**TOWN OF BROOKLYN
PLANNING AND ZONING COMMISSION
Regular Meeting Agenda
Wednesday, October 7, 2020
6:30 p.m.**

SUBJECT: Proposed Parking Expansion
Vachon Chevrolet
Assessor's Map 41, Lot Nos. 13A & 14
Providence Road (Route 6)
Brooklyn, Connecticut

ENGINEERING PLAN REVIEW PERTAINING TO PROPOSED PARKING EXPANSION VACHON CHEVROLET (ASSESSOR'S MAP 41, LOTS 13A & 14) PROVIDENCE ROAD (ROUTE 6) BROOKLYN, CT (March 20, 2020)

ENGINEERING PLAN REVIEW PERTAINING TO A 3-LOT SUBDIVISION (ASSESSOR'S MAP 34, LOT 52) PRINCE HILL ROAD BROOKLYN, CT (September 1, 2020)

SHEET 3 OF 5 – SITE DEVELOPMENT PLAN NO. 1

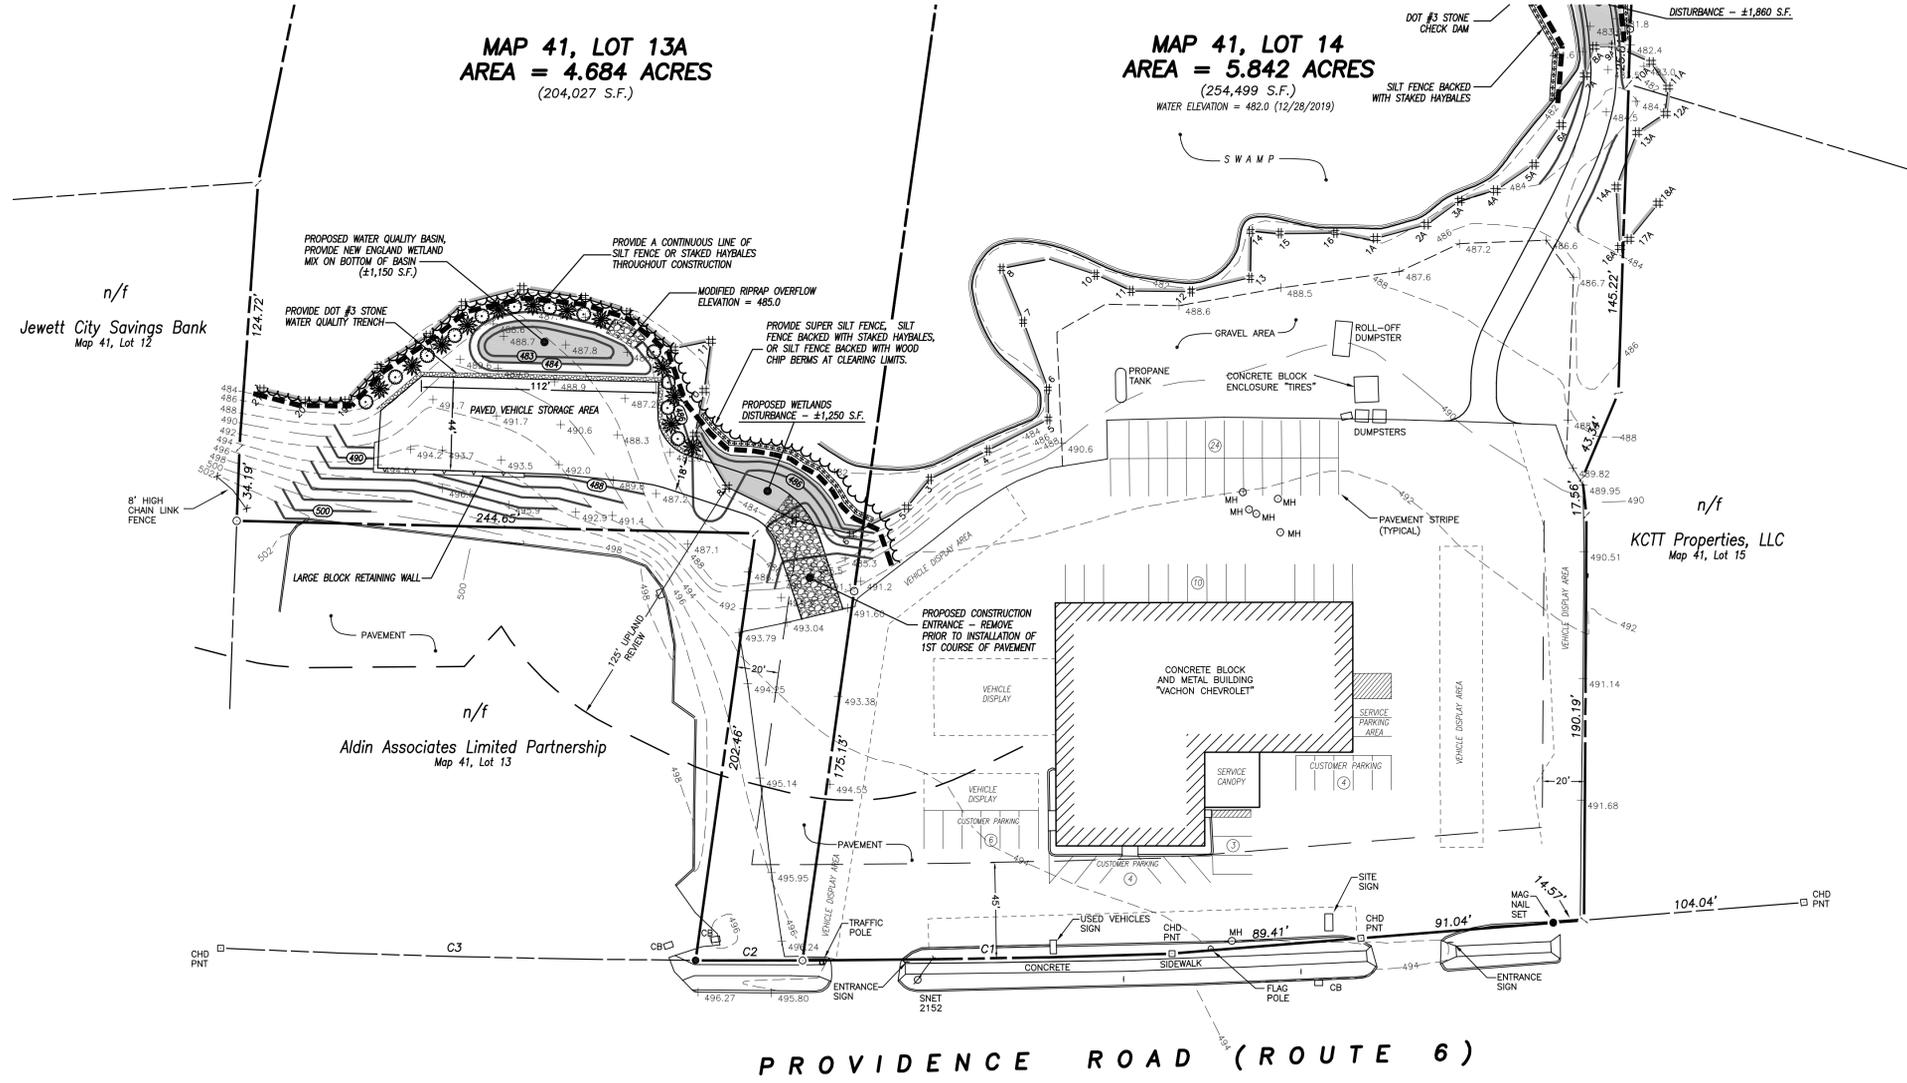
1. A construction entrance symbol is drawn at the entrance to the new "paved vehicle storage area." However, a note should be included to indicate that this will be removed at the time the first course of paving is installed for the vehicle storage area. Additionally, it would be helpful for this explanation to be included in Note 17 under "Development Schedule/Sequence of Operations" that appears on Sheet 5 of 5 of the plan set.
2. The note "Silt Fence Backed with Staked Haybales or Wood Chip Berms" should read the same as the note on Sheet 4 of 5, "Provide Super Silt Fence, Silt Fence Backed with Staked Haybales, or Silt Fence Backed with Wood Chip Berms at Clearing Limits," for consistency.

1. A note has been added to the plan to direct the contractor to remove the anti-tracking construction entrance prior to installing the first course of pavement. This has also been noted on sheet 5 of 5 in the development schedule/sequence of operations.
2. The note "silt fence backed with staked haybales or wood chip berms" has been modified to read the same on all sheets.

SHEET 4 OF 5 – SITE DEVELOPMENT PLAN NO. 2

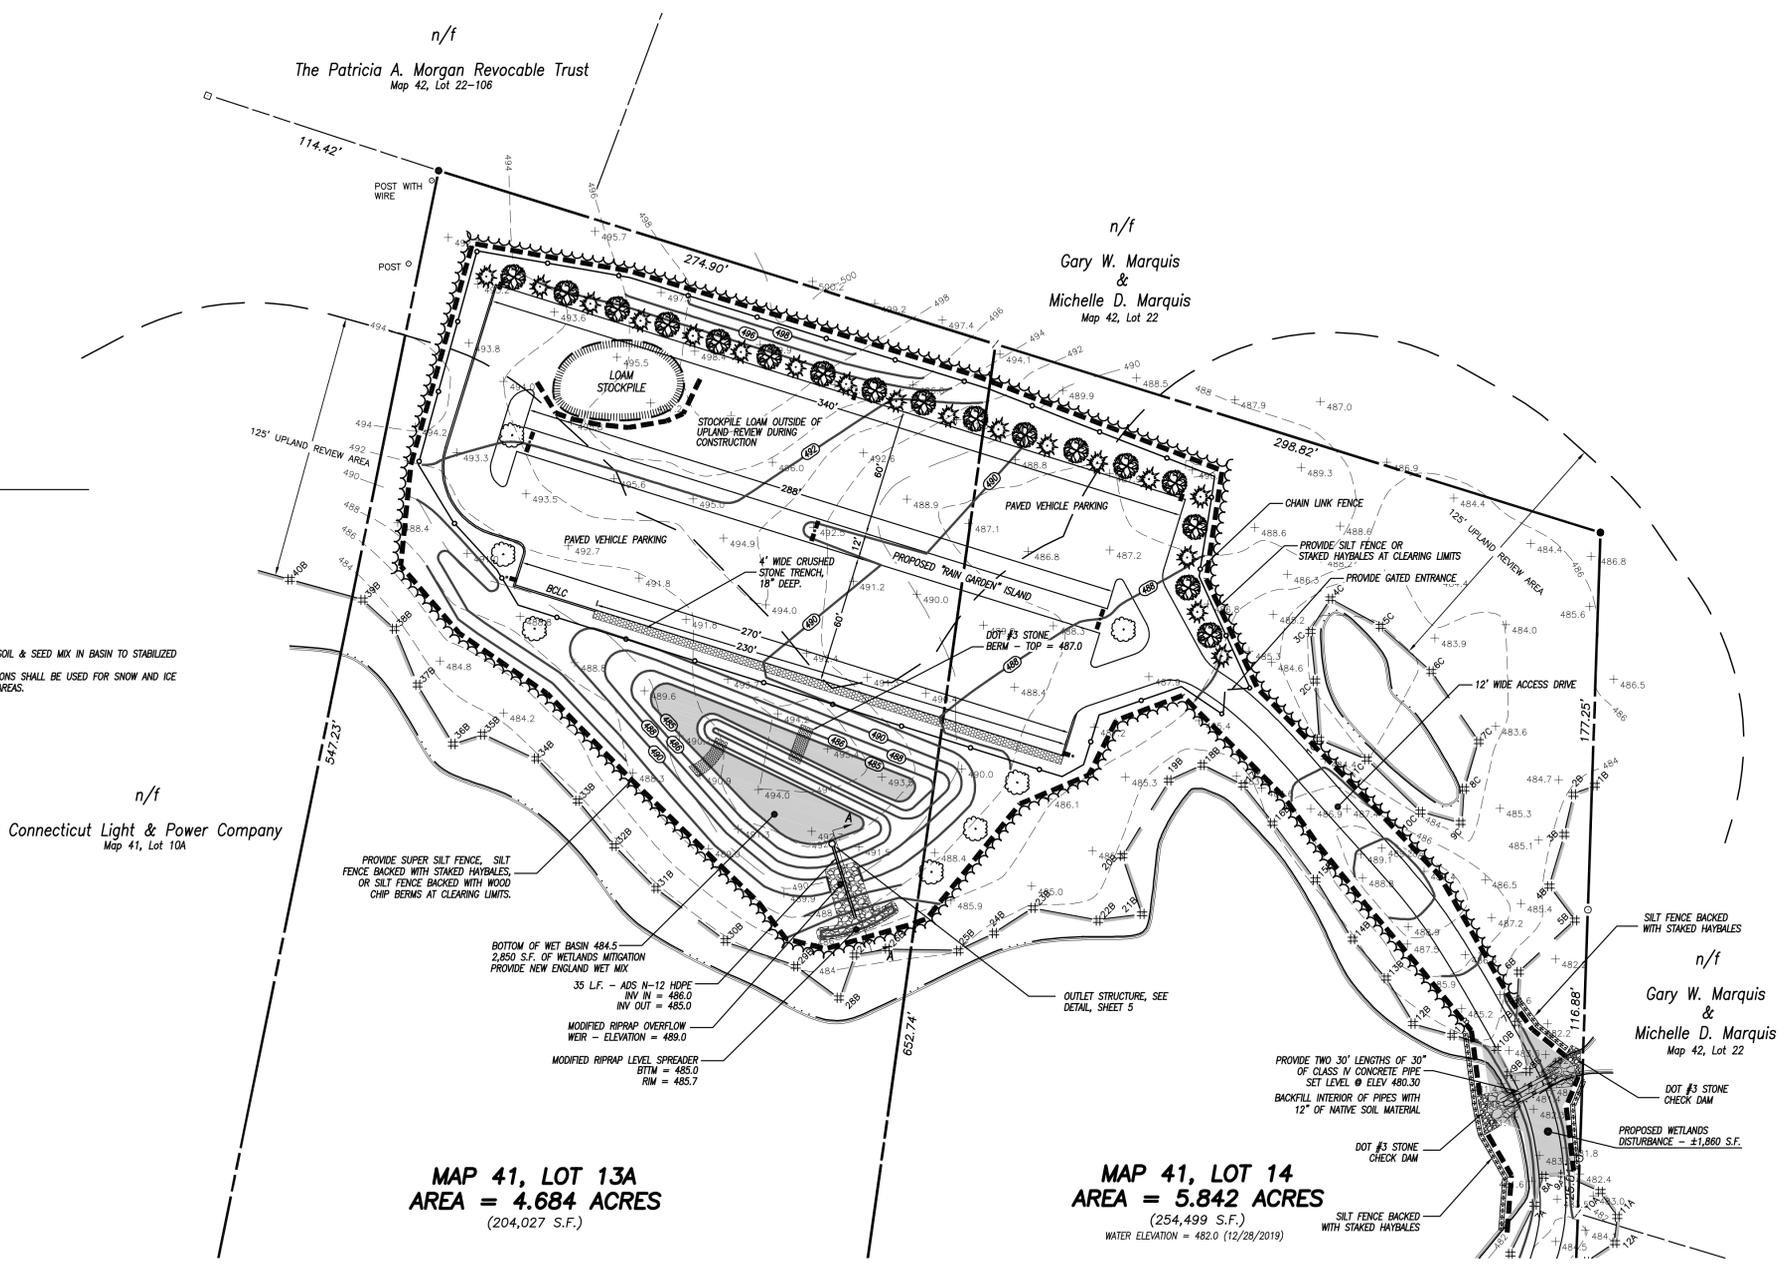
1. Proposed slopes in the detention basin range from 1:1 to 3:1. It is recommended that slope be uniform and that no slopes be steeper than 3:1 to reduce the tendency of soil erosion
2. Pedestal lighting, with dual light fixtures, is shown at three (3) locations in the middle of the proposed vehicle parking area. No description of the lighting assembly (pedestal height, pedestal base, full cutoff design, wattage, etc.) can be found in the plans under review. This is important since there is a house on adjacent Lot No. 22 that is not too distant from the north property line in the vicinity of the proposed construction on the Vachon property. It should also be noted that the

majority of the visual/sound barrier created by the existing mature forest in this area between the house and the proposed development is going to be removed, only to be replaced by young plantings that will take many years to reestablish the buffer. Therefore, has the impact of lighting and noise on the adjacent residence been evaluated to determine if there will be any significant impact to it?

3. How will snow removal be handled in this area so as not to impact the adjacent wetlands (salt or other ice removal chemicals) and proposed landscaping?
4. It is unclear on how the "island" in the middle of the proposed parking area is going to be constructed, i.e., raised island with landscaping; raised island paved with no landscaping; flush with whatever in between; etc.? Can this area be used as a rain garden to mitigate some of the runoff from the pavement?
5. Is there any consideration to provide some form of "tall" landscaping in the center island, considering how much impervious pavement is being proposed?
6. As an aid to construction, it would be helpful to include a cross-section profile from the detention basin outlet structure to just beyond the level spreader.

2. A detail for the lighting fixture with the make and model number has been added to the plans. We have also enclosed a cut sheet for the lighting as well. The chosen fixtures will be mounted no higher than 12' and are dark sky compliant. In addition, the landscaping proposed between the parking and the residences to the north will provide a very good vegetated buffer; cut sheets for the chosen plantings is included with this submission. Currently, the existing pine trees do not provide any visual buffer. As with most larger pine trees, there are minimal branches at the bottoms of the trees up to 20' or more. With regard to noise, this area will be utilized to store inventory and will not be accessed by the general public unless accompanied by a sales representative.

3. Snow will be stockpiled at the top of the slope adjacent to the proposed stormwater basin. Sheet 5 of the plans specify that no salt or chemical applications for snow removal shall be used.

4. The island in the center of the site will be depressed. We will incorporate rain garden plantings into the island to promote stormwater treatment and infiltration.
5. As the center island will be utilized in the capacity of a rain garden, we do feel that taller vegetation would be appropriate.
6. A cross section of the basin outlet has been added to the plans as requested.

STORMWATER BASIN OUTLET STRUCTURE DETAIL
NOT TO SCALE

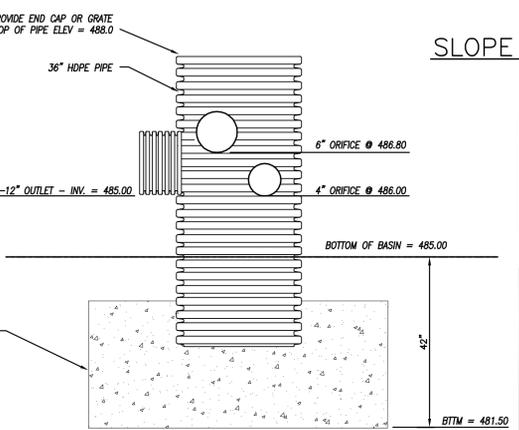
1. In the "Stormwater Basin Outlet Detail," a smooth outer wall PVC pipe may be less susceptible to upheaval or degradation (breakage) by icing conditions than a corrugated type of pipe. It is recommended that this be evaluated by the designer. Furthermore, over time, ultraviolet rays in sunlight degrades unprotected plastic pipe, which causes it to lose structural integrity and stability. Considering this, concrete may be a better choice.

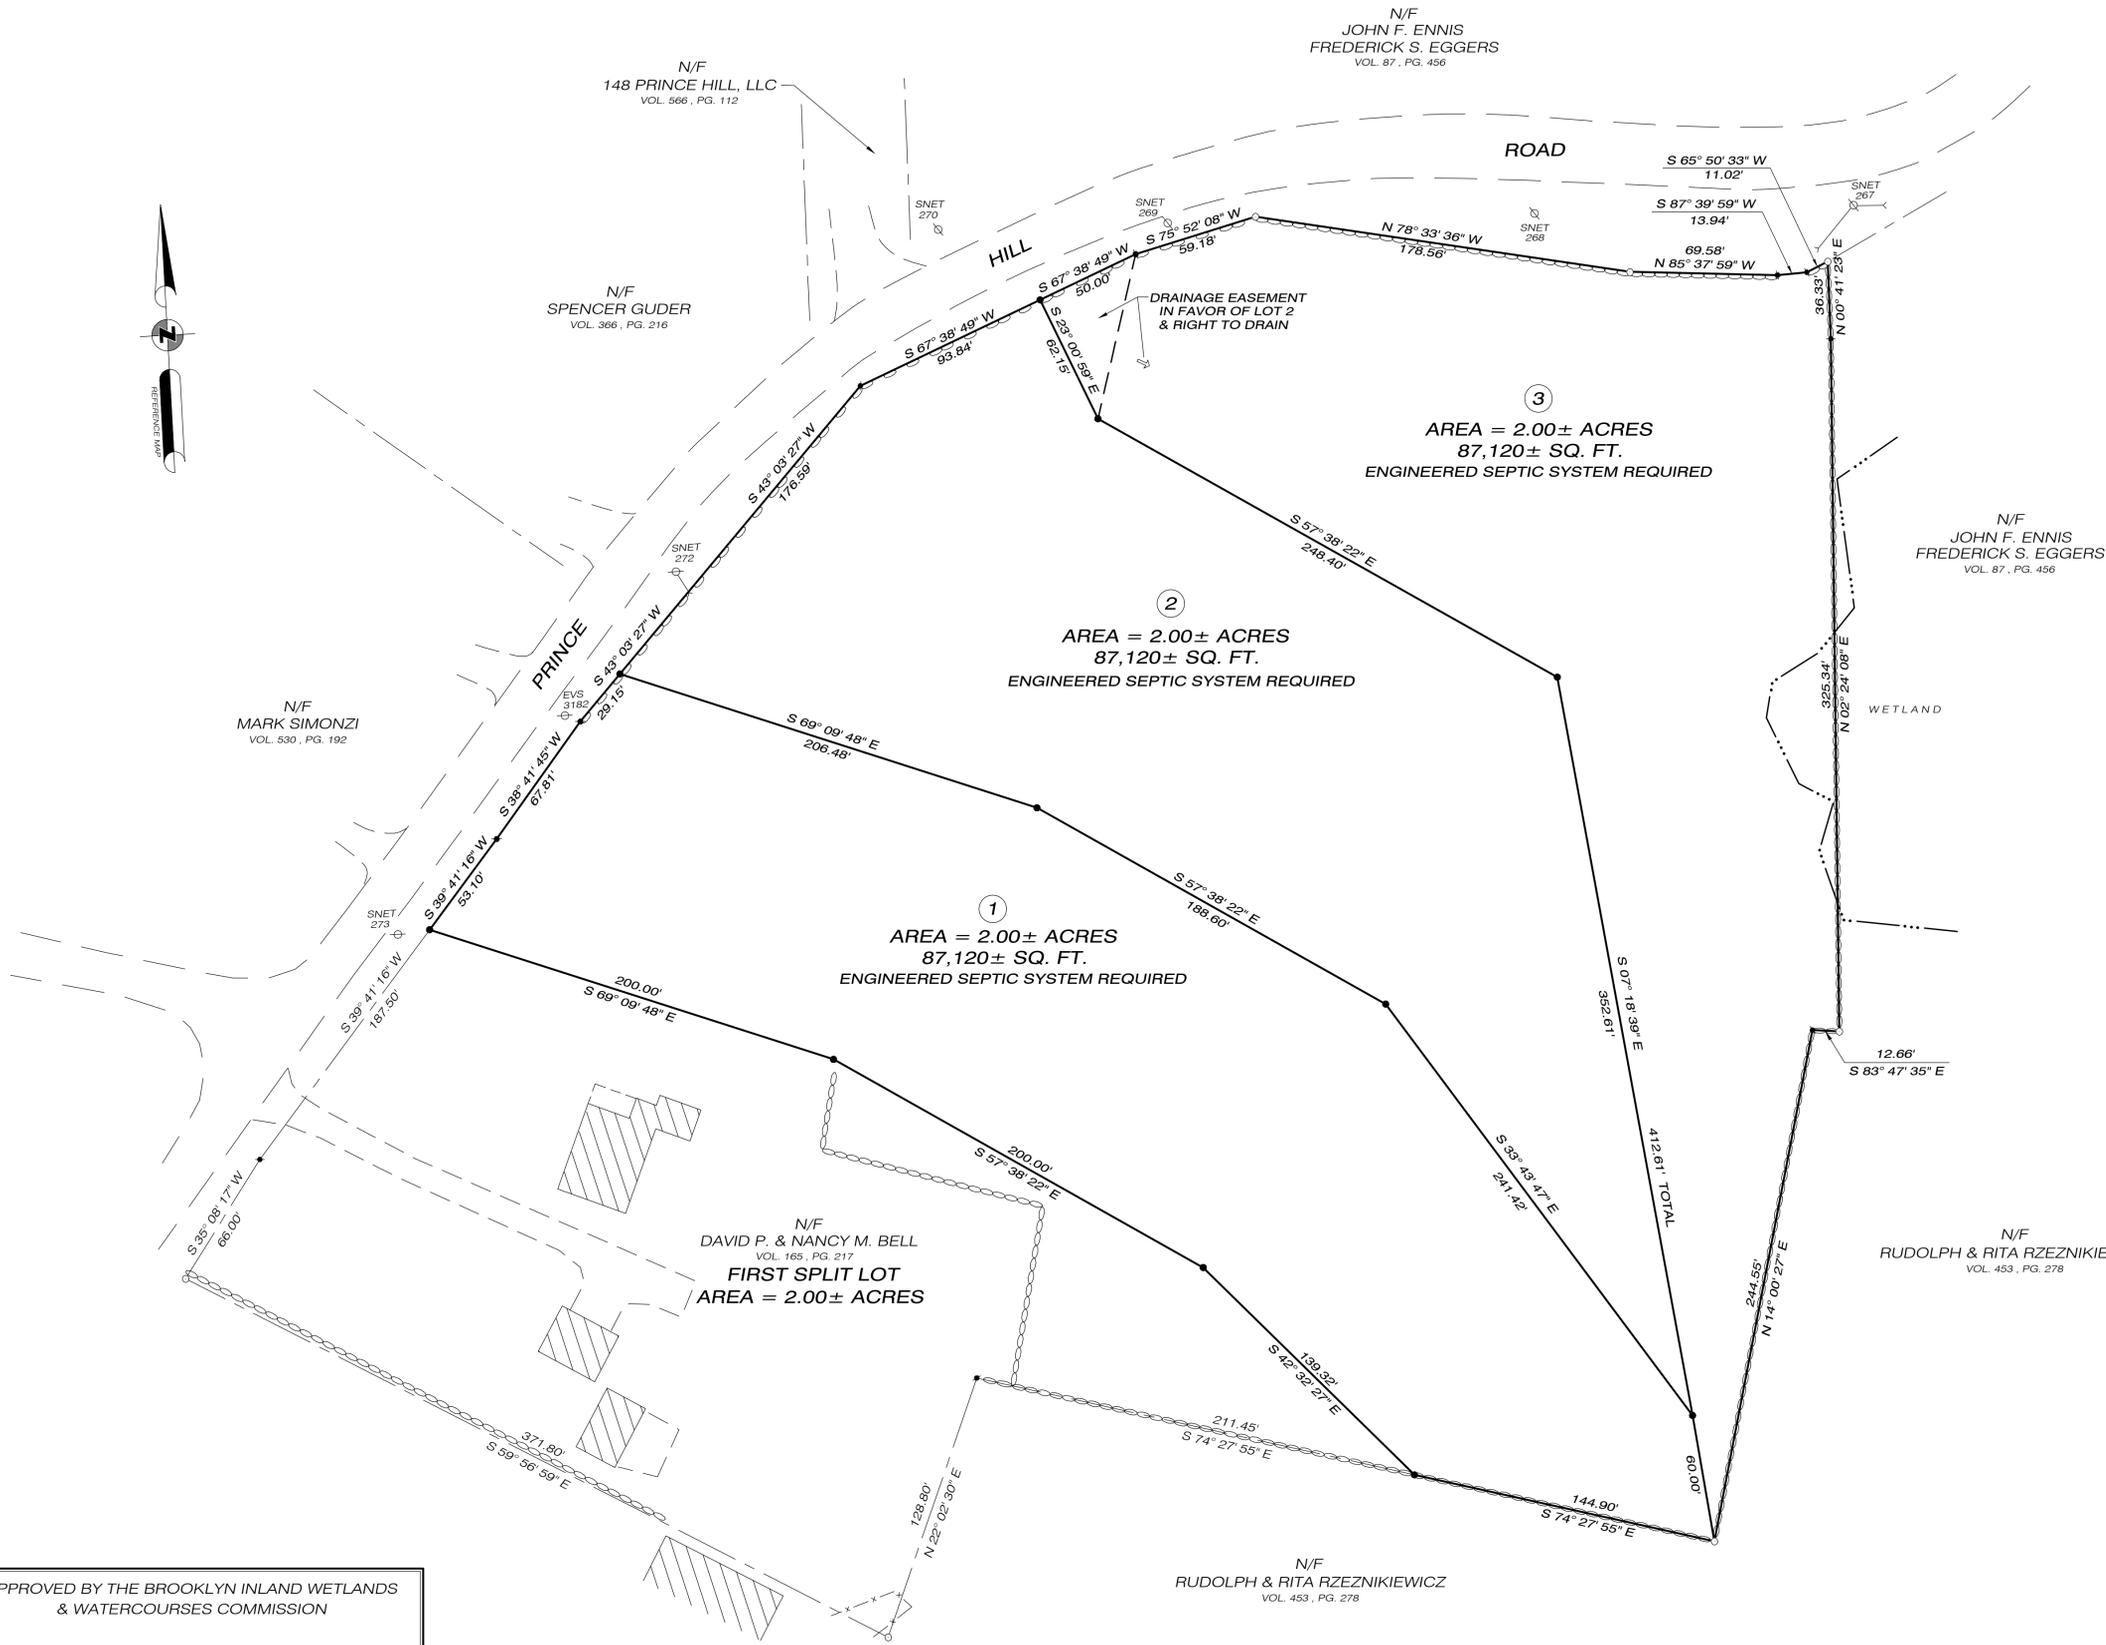
1. The Conservation Easement shown on previous plan submissions has been removed. A note on Sheet 2 of 4 of the most recent plans states that the Applicant shall pay an Open Space Fee in lieu of adding further protection to the wetland with a Conservation Easement.

2. The Sight Line Easement shown on previous plan submissions on the Subdivision Plan, Sheet 2 of 4, has been eliminated. It is my opinion that the easement is required and should be redrawn on this plan sheet and on the Lot Development Plan, Sheet 3 of 4. Incidentally, proposed grading is shown on Sheet 3 of 4 to provide a good sight line to the east for a vehicle exiting the driveway of Lot 2 and motorists traveling eastbound on Prince Hill Road.
